**EIA Report on
Development of a 100MW Offshore Wind Farm in Hong Kong**

**Supplementary information provided by the project proponent
at the request of the EIA Subcommittee**

Figure 2: Preliminary Schedule for Design and Construction Works for the Southwest Lamma Wind Farm

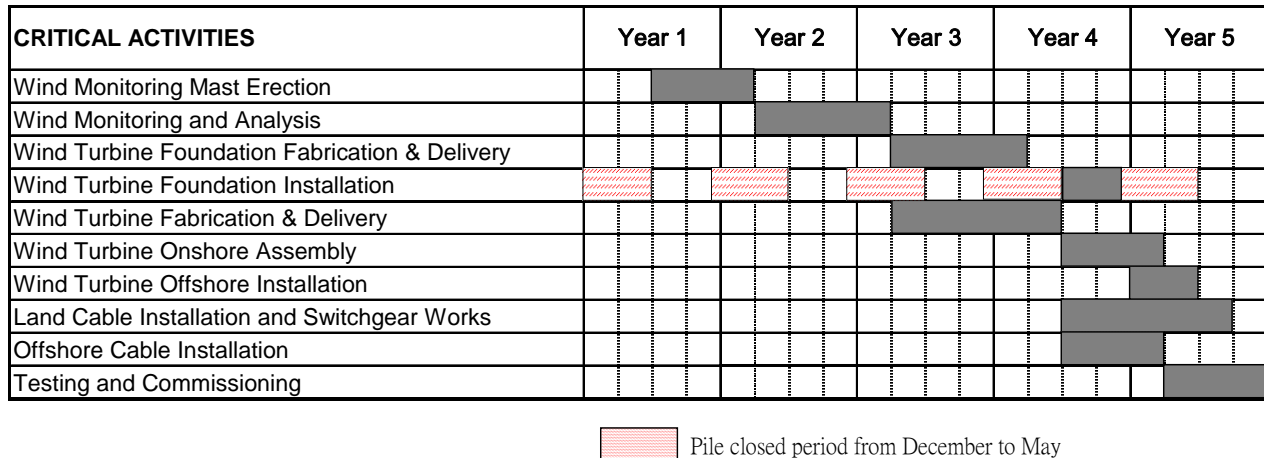
(b) A more detailed construction programme for the detailed design and construction phases.

Further to the indicative schedule for the construction of the offshore wind farm at Southwest Lamma presented in the EIA report (*Section 5.7*), a more detailed schedule is presented in *Figure 2* below. Within this programme, the activities associated with the percussive piling works as well as those period committed to be closed for piling works are presented.
